OFFICE OF RIVER PROTECTION

SUBMITTAL OF HANFORD FACILITY RESOURCE CONSERVATION AND RECOVERY ACT PERMIT MODIFICATION NOTIFICATION FORM 24590-LAW-PCN-ENV-17-012

**Hanford Facility RCRA Permit Modification Notification
Form 24590-LAW-PCN-ENV-17-012**

Hanford Facility RCRA Permit Modification Notification Form
Part III, Operating Unit 10
Waste Treatment and Immobilization Plant

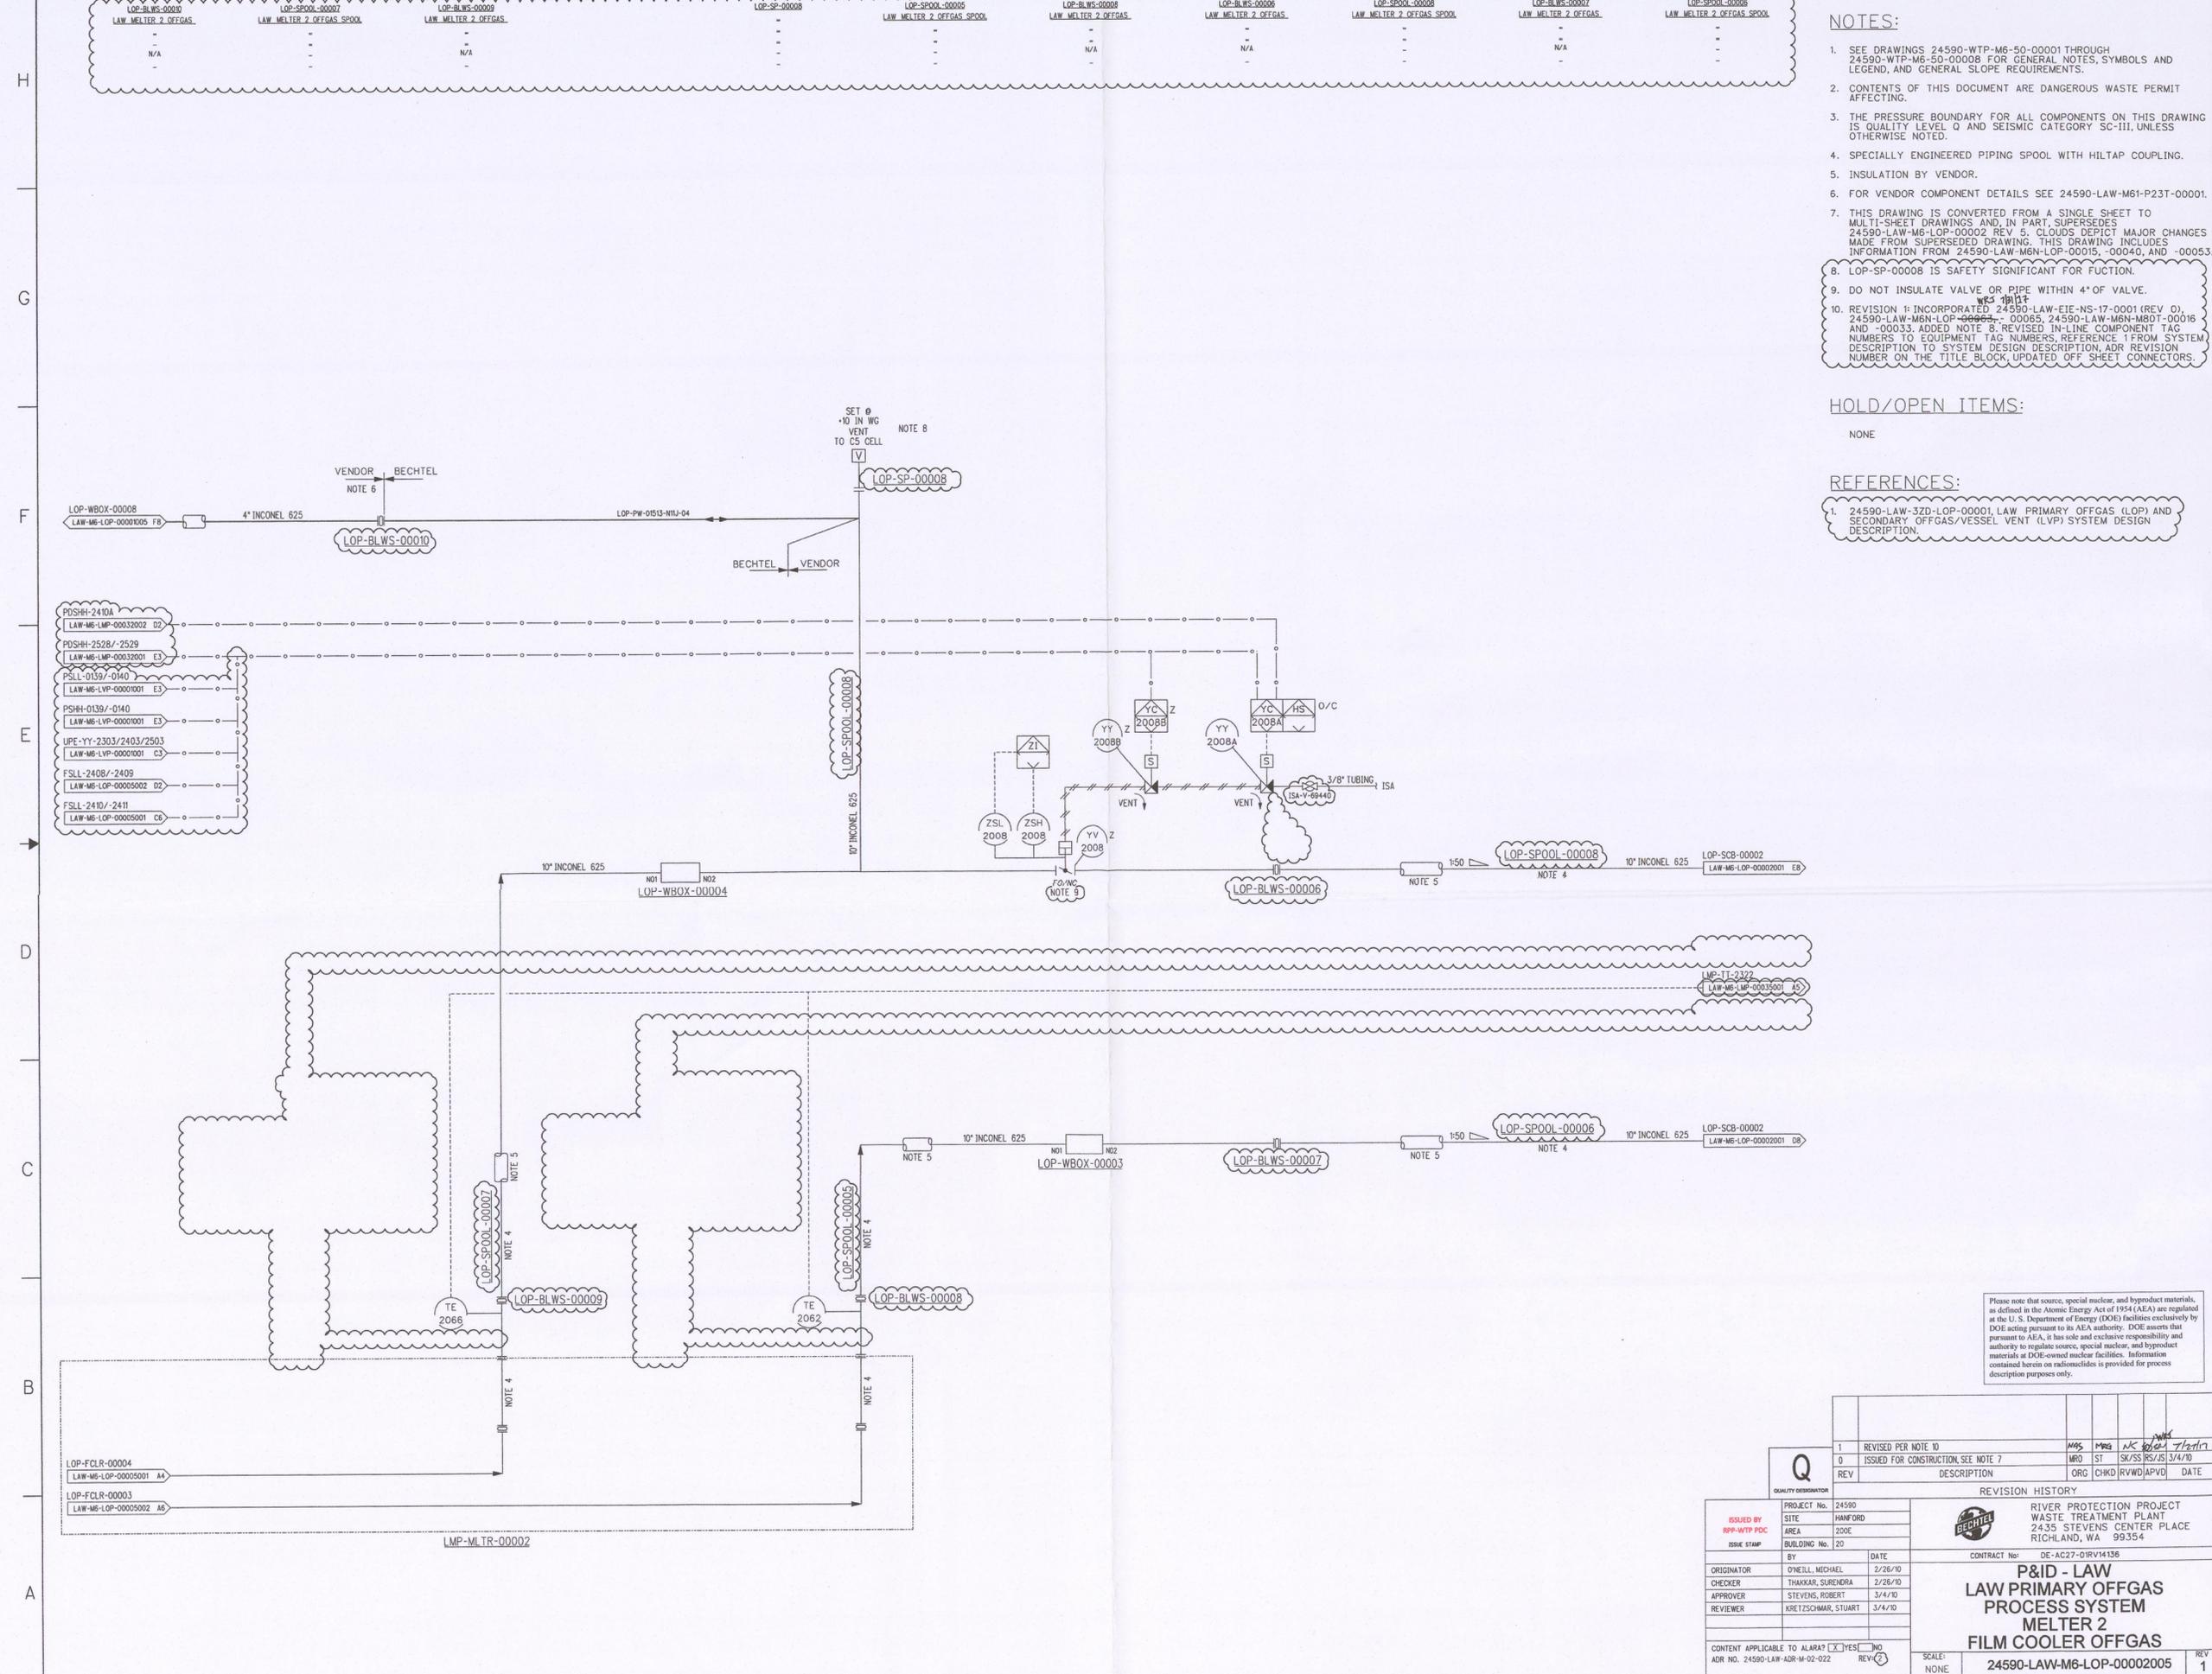
Changes to the P&ID (24590-LAW-M6-LOP-00002005, Rev. 1) for the Melter 2 Film Cooler Offgas are summarized below:

- Added notes in the Notes section. Revised the References section.
- Added equipment identification labels (Grids H2 to H8).
- Changed valve symbol from gate valve to ball valve for ISA-V-69440 (Grid E4).
- Deleted seismic and quality flags near valve ISA-V-69440 (Grid E4).
- Deleted temperature indicators TI-2152 and TI-2153 and associated instrumentation and lines (Grids B6 to B8, C6 to C8 and D2 to D8).

- Added, revised or deleted off-sheet connectors (multiple grids).
- Incorporated changes from change documentation identified in the Notes section.

LOP-FCLR-00002
MELTER 1 STANDBY
OFFGAS FILM COOLER
21W x 38" L x 57H

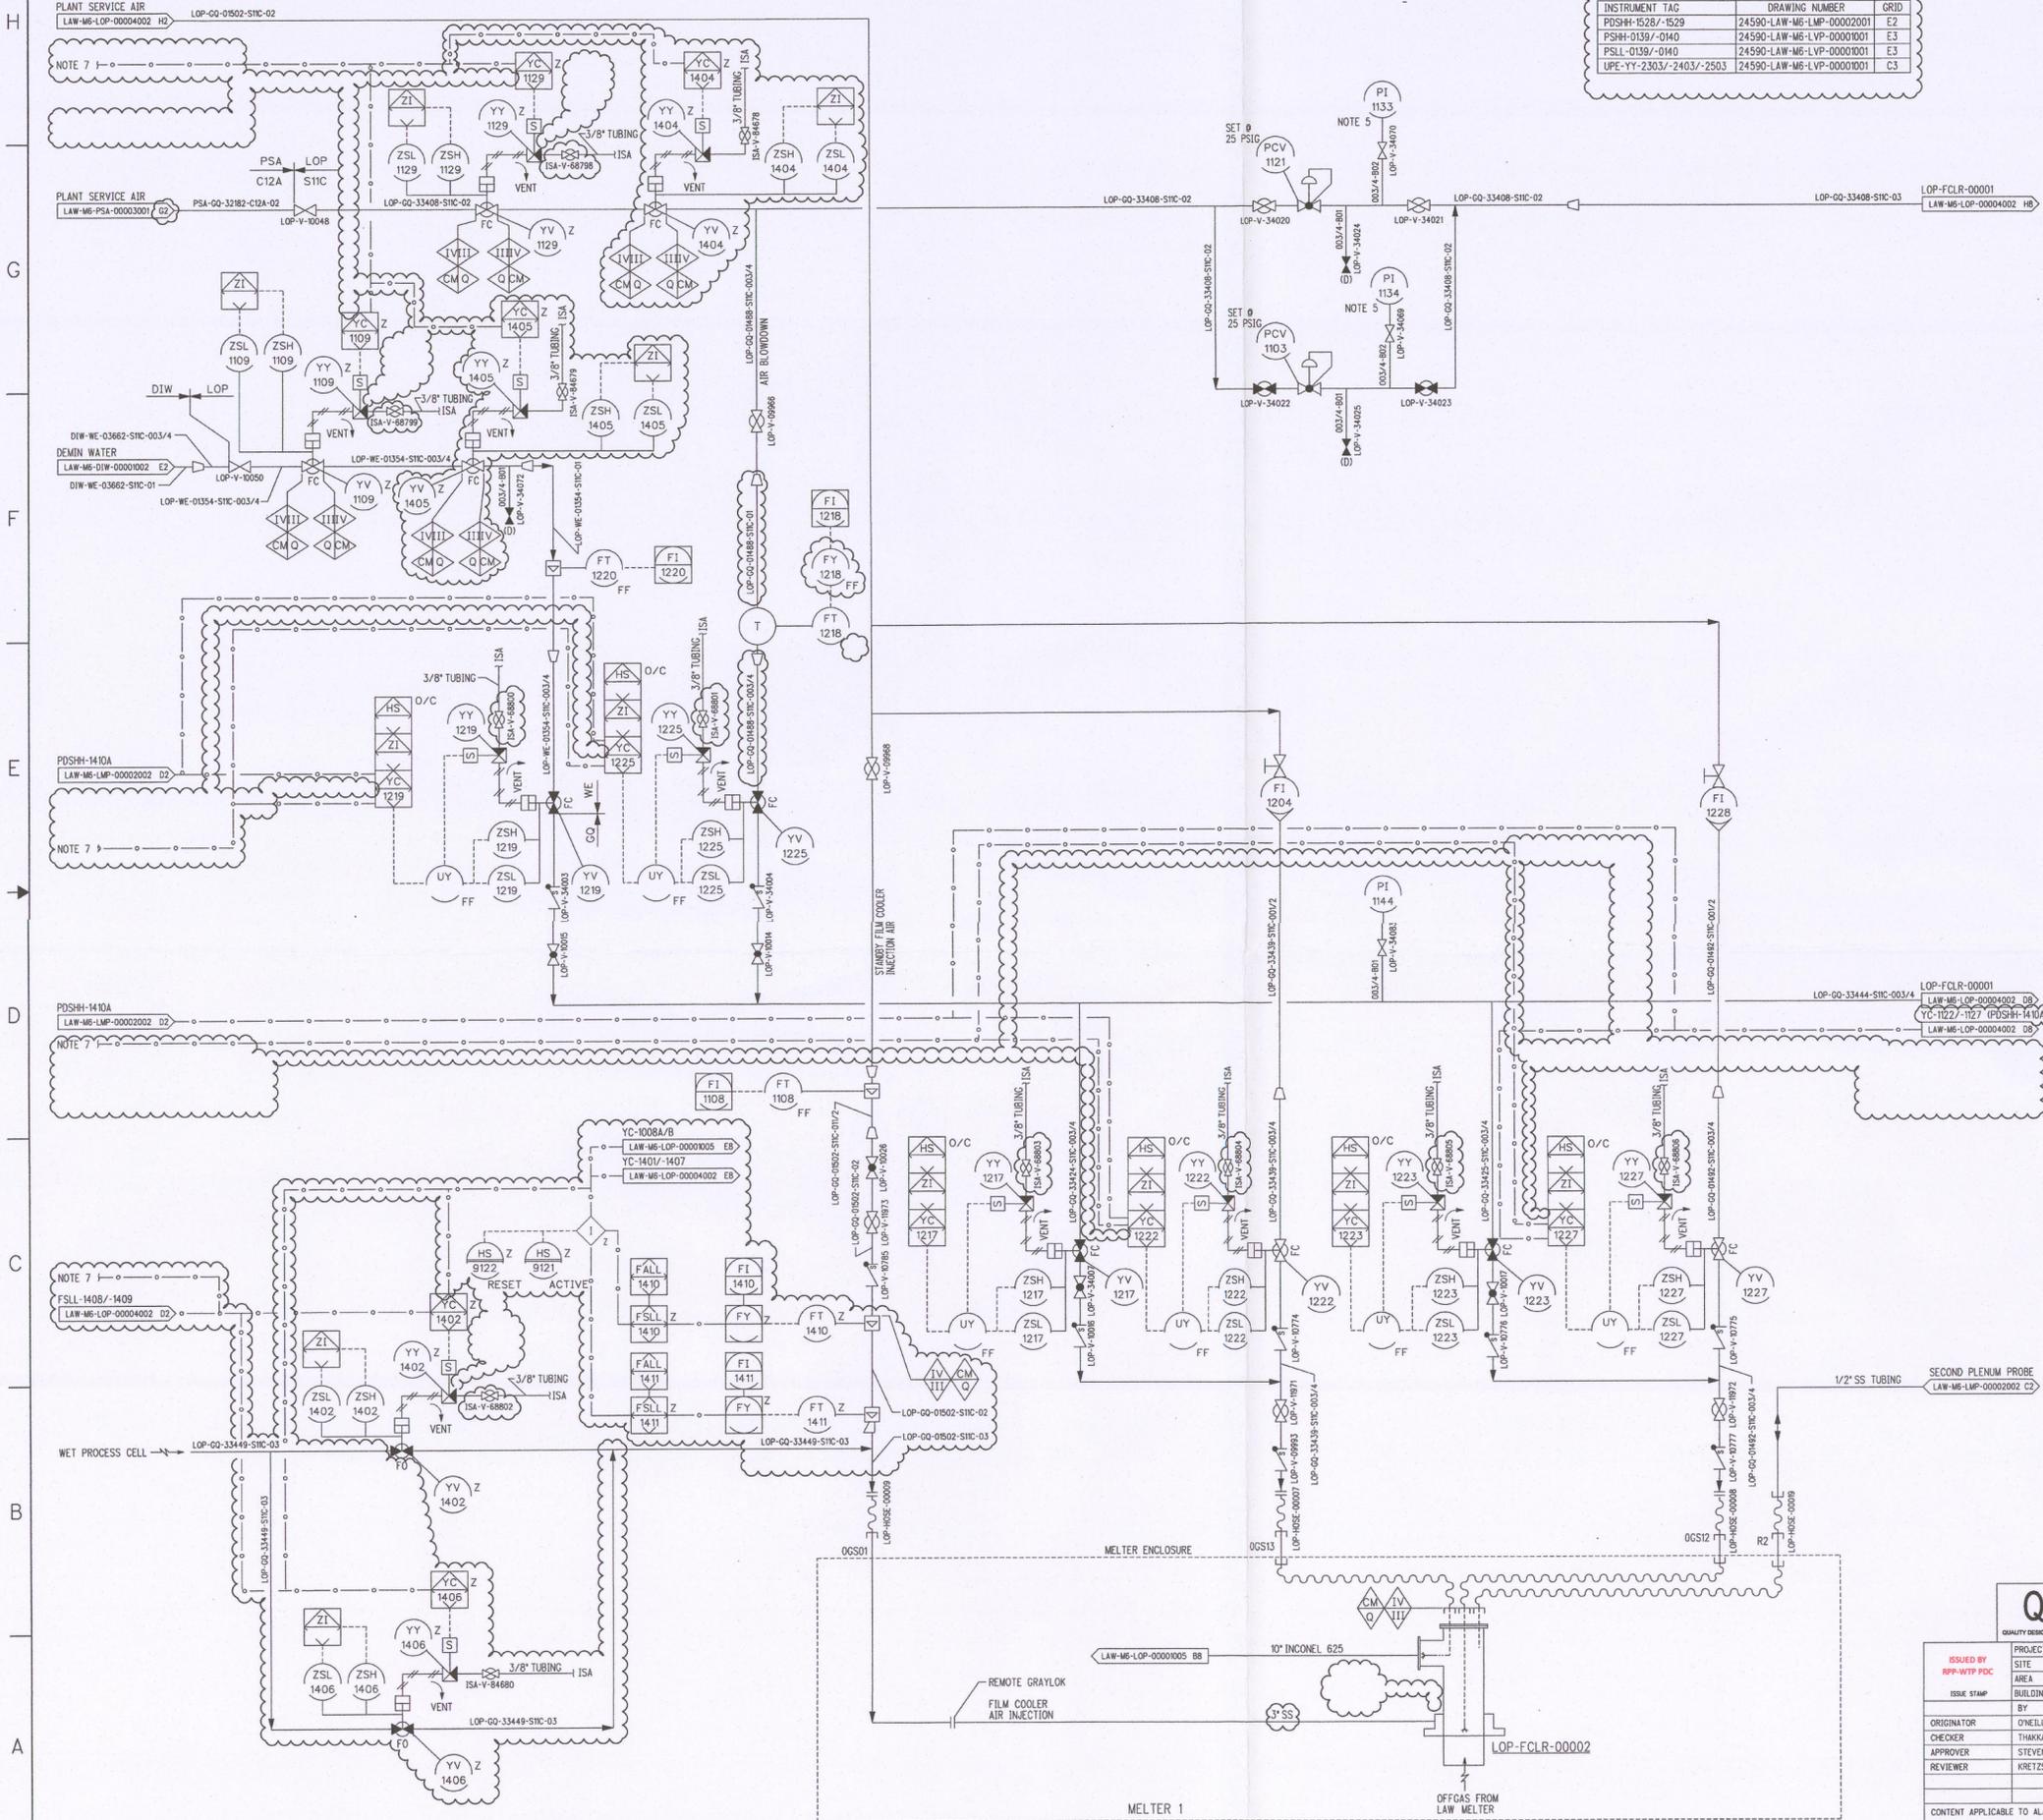
Changes to the P&ID (24590-LAW-M6-LOP-00004001, Rev. 1) for the Melter 1 Standby Offgas Film Cooler (LOP-FCLR-00002) are summarized below:

- Added notes in the Notes section. Revised the References section.
- Added new Table 1 (Grid H3).
- Added 1" reducers upstream and downstream of flow rate transmitter FT-1218 (Grids E6 and F6).

- Added Foundation Fieldbus converter FY-1218 and revised FT-1218 (Grid F6).
- Revised instrumentation control strategy by the addition of instrumentation, lines, and valves (multiple grids).

- Changed valve symbol from gate valve to ball valve for ISA-V-68798 through ISA-V-68806 (Grids B7, C3 to C5, E6 to E7, F7 and G7).
- Deleted seismic and quality flags near film cooler LOP-FCLR-00002 and LOP valves ISA-V-68798, ISA-V-68799 and ISA-V-68802 (Grids A4, B7 and G7).

- Added valve YV-1406 and associated instrumentation and lines (Grids A6 to A8, B6 to B8 and C6 to C8).
- Revised the diameter size from 2" to 3" for air injection piping LOP-GQ-01502-S11C-03 upstream of film cooler LOP-FCLR-00002 (Grid A4).

- Added, revised or deleted off-sheet connectors (multiple grids).
- Incorporated changes from change documentation identified in the Notes section.
